Subject: Steinmann SFD (DRC2014-00039)

SUBJECT: Response to California Coastal Commission Comments
13th Street at Highway 1, APN: 073-095-007
Cayucos Area, San Luis Obispo County, California

ENGINEERING GEOLOGY MAP

RE: Joe Steinman residence, APN: 073-095-007 (@ Cabrillo Avenue) in Cayucos CA

PLATE
1
PROJECT
SL01205-6

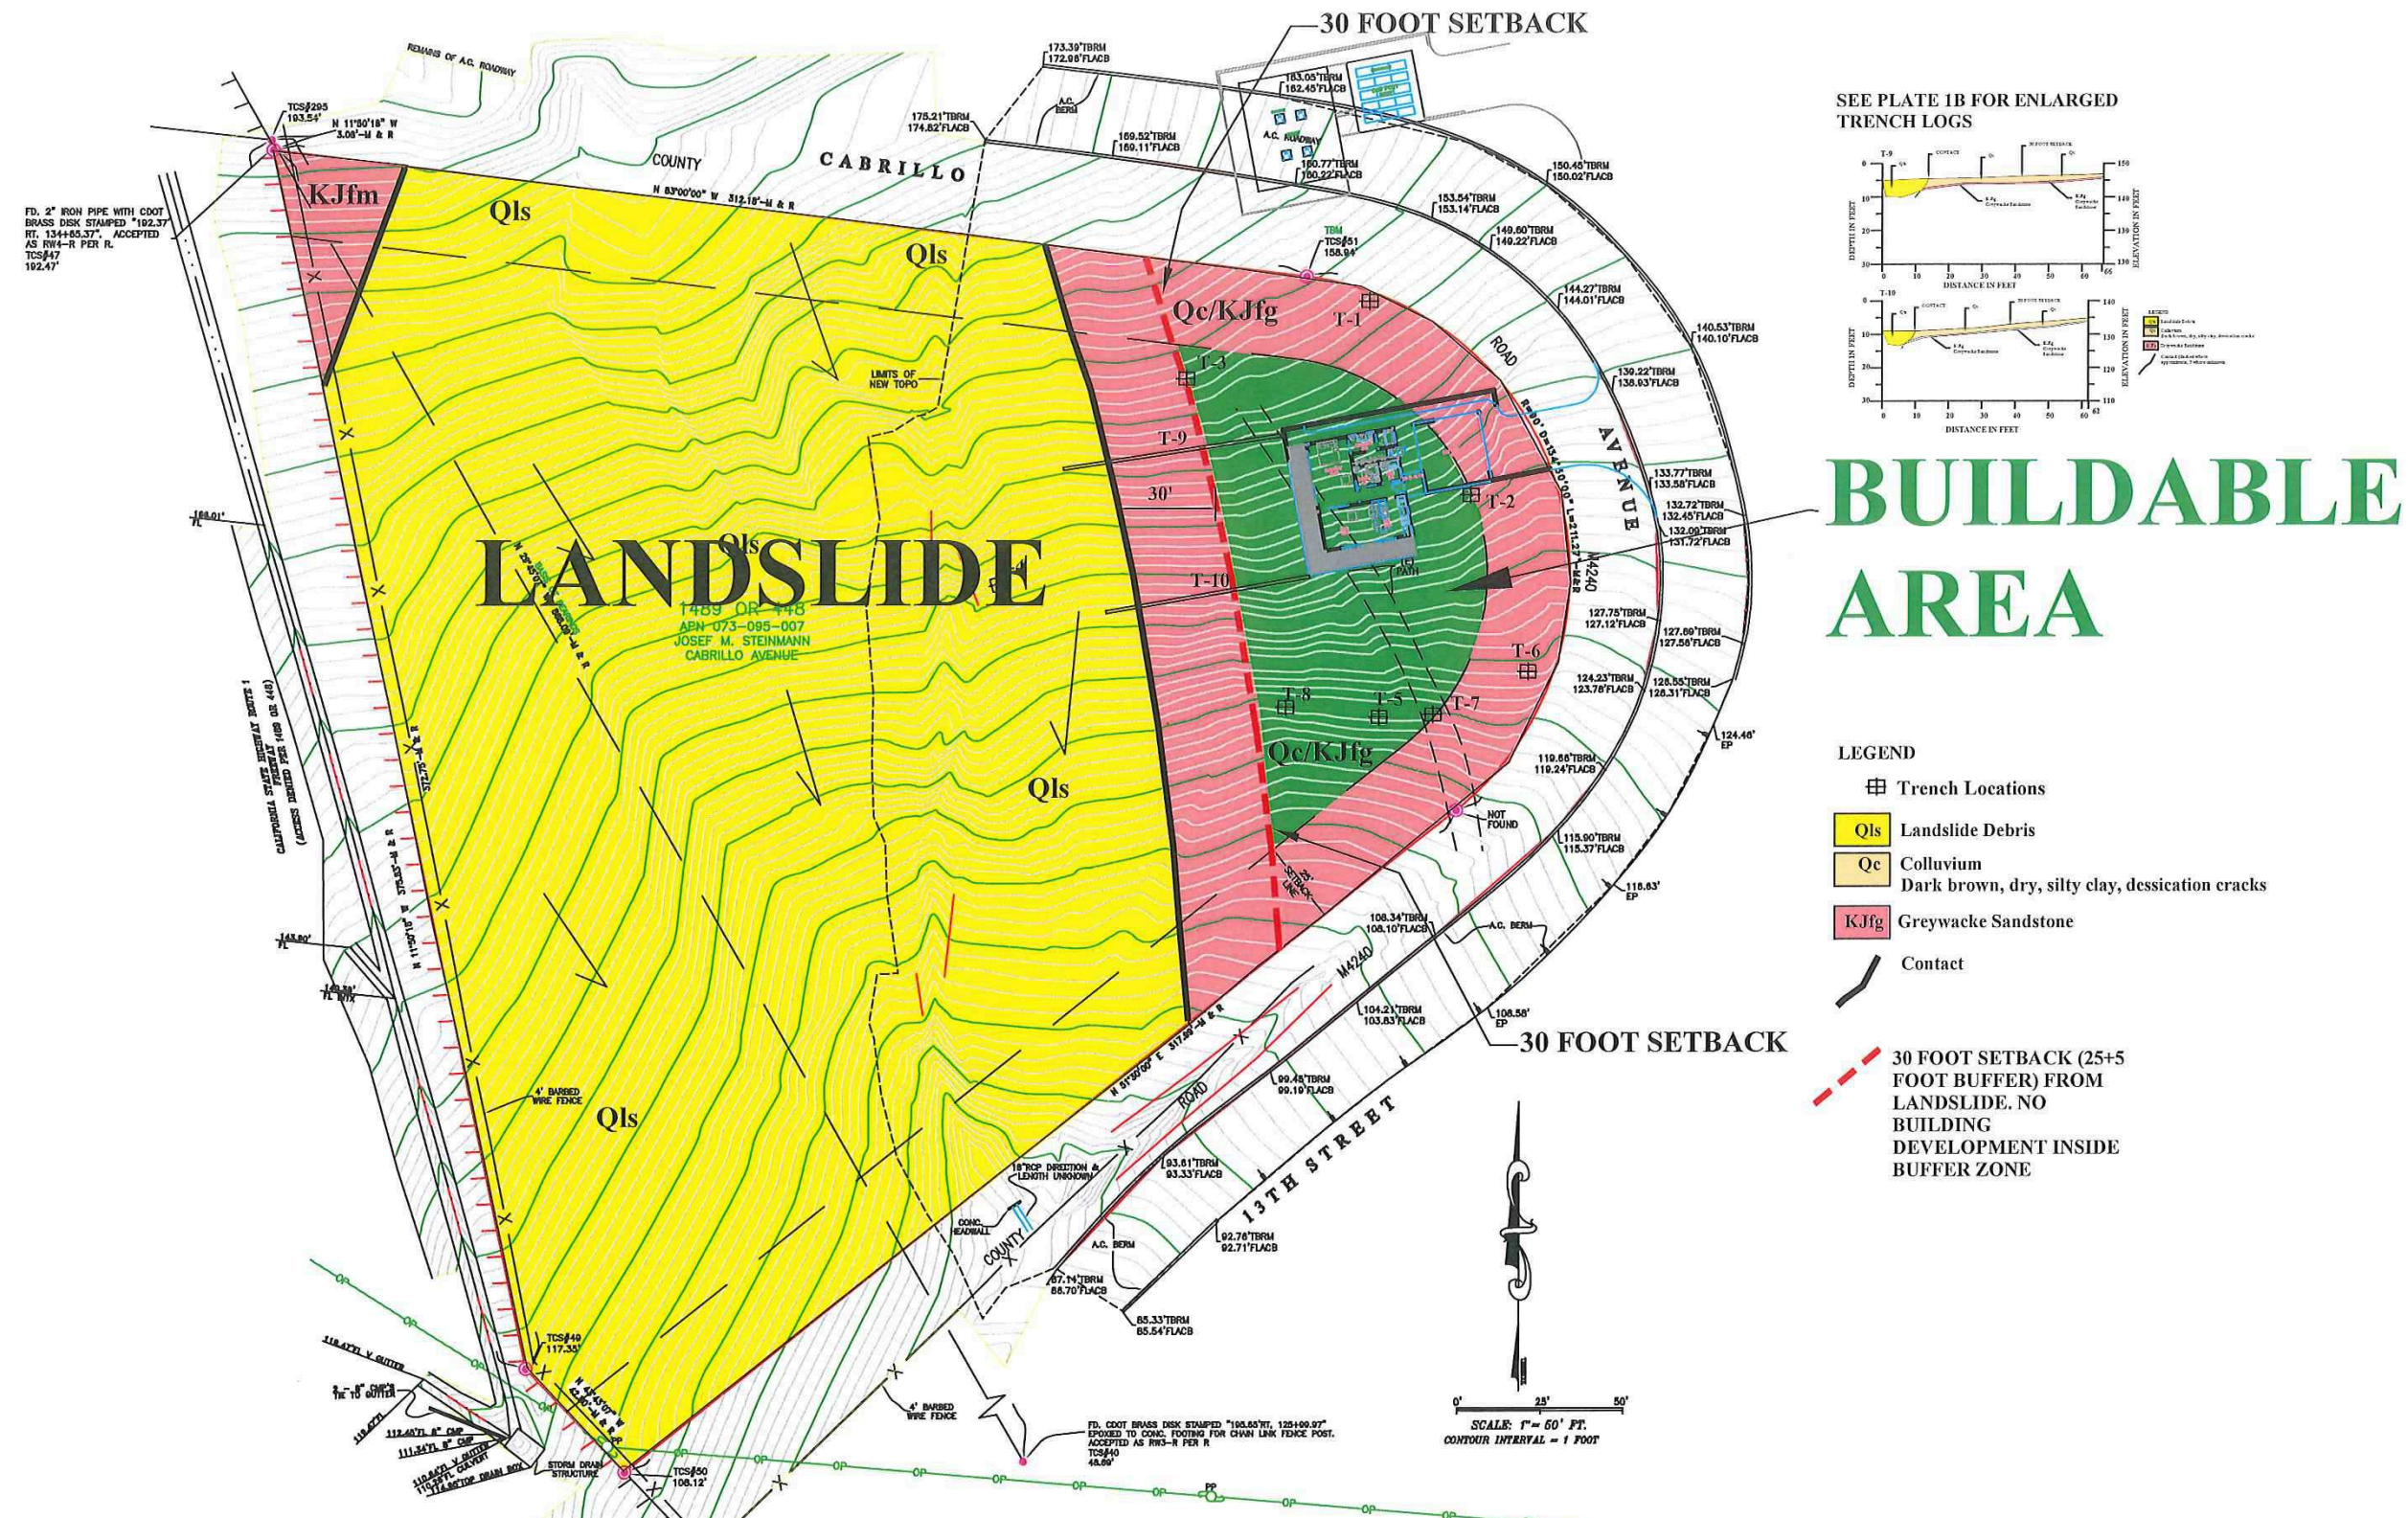
1. **Visual resource protection.** It is our understanding that the County has analyzed the potential visual impact of the proposed 1,200 square foot residence from public views, including Highway 1. The Applicant has agreed to initially plant 15 gallon-sized trees (6-10 feet tall) with the expectation that these trees are to achieve at least 75% screening upon maturity (approximately 10 years), and the County has indicated they will condition the permit to ensure that the landscaping be maintained in perpetuity. In addition, it is our understanding that the project will be conditioned by the County to require a material and lighting palette for visual compatibility prior to issuance of the building permit. We have also been sent the Applicant's visual simulations which show the home with and without the vegetated screening at full maturity from three key viewpoints along Highway 1.

As you know, this parcel is within the Local Coastal Program (LCP)'s mapped Critical Viewshed, and thus the project will need to be consistent with Estero Area Plan Section IV(C) Cayucos Critical Viewshed policies and CZLUO Section 23.04.210 standards. In addition, the project will also need to be consistent with the LCP's Coastal Plan Policies for protection of scenic and visual resources. From the visual simulations, we have concerns that the proposed project is designed and built to be subordinate to, and blend with, the character of the area (as required by 23.04.210(c)(1)), including because it appears to introduce a large residential structure into a highly visible rural, agricultural hillside. In addition, it is unclear that the proposed vegetative screening alone will sufficiently mitigate the project's impacts, and be sufficient to bring the project into compliance with the suite of LCP visual resource policies. Besides being visible from Highway 1 even after all screening is at maturity, it appears that the screening will be introducing a significant number of trees into an area that currently consists of sparsely

vegetated grazing lands, inconsistent with 23.04.210(c)(3) ("the use of vegetation appropriate to the site shall be similar to existing native vegetation"). It appears that alternatives exist to the design that may minimize visual impacts, including by reducing the size of the structure and/or sinking portions of it below grade, as well as alternative building sites, including towards the lower end of the parcel near Cabrillo and 13th Streets and/or in slope created "pockets" (and perhaps below grade of Highway 1) that would reduce the visual impacts from Highway 1. These alternative sites should be analyzed to ensure consistency with the LCP and described in detail in the County's staff report.

Plate 1 depicts the location of buildable area for site development at the subject property. Development outside the buildable area would either be within applicable setbacks as directed by the County of San Luis Obispo, or would be in landslide deposits and would require large-scale earthmoving and grading activities of the site in preparation for site development. The proposed building location and buildable area depicted on Plate 1 is geologically suitable provided that the recommendations provided within the referenced GeoSolutions, Inc. documents herein are implemented. The proposed work should not affect the geologic stability of the proposed development site provided the recommendations are implemented. It is GeoSolutions, Inc. recommendation that the proposed subject residence not be situated outside of the buildable area as depicted on Plate 1 unless landslide mitigation is performed which would require large-scale earthmoving and grading activities of the site in preparation for site development and require extensive consultation with GeoSolutions, Inc.

landslide. Landslide movement is toward the south. A building setback zone was discussed in the field and a 25-foot setback from the landslide was established with a factor of safety buffer of 20% (5 feet) and is demarcated on Plate 1 (for a total of a 30-foot setback from the landslide for site building development). The 25-foot setback is derived from the local coastal plan whereby coastal properties must maintain a minimum of 25-feet from top of bluff for new development. Development may occur east of the 30-foot setback line. Due to the known location of the landslide, the absence of landslide material at the proposed residence site, and the stated setback, the potential for the house to be affected by the western landslide is low.

Plate 1 depicts the buildable area for the site based upon setbacks of: 1) landslide setbacks; 2) development setbacks dictated by property boundaries; and 3) competent geologic formational material. It is GeoSolutions, Inc. recommendation that the proposed subject residence not be situated outside of the buildable area as depicted on Plate 1 unless severe site grading and extensive consultation with GeoSolutions, Inc. ensue.
